ADA Curb Ramp New Construction Inspection Form (Perpendicular)

Ramp Style **PR**

PERPENDICULAR RAMP (PR)

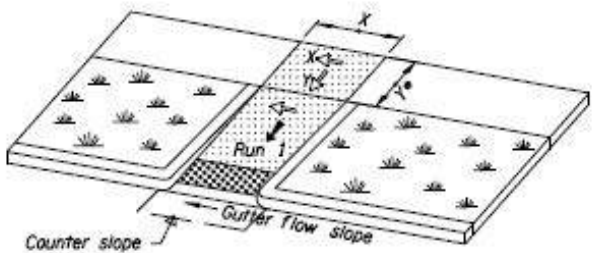
Comments:  
ICRR RR1 fail
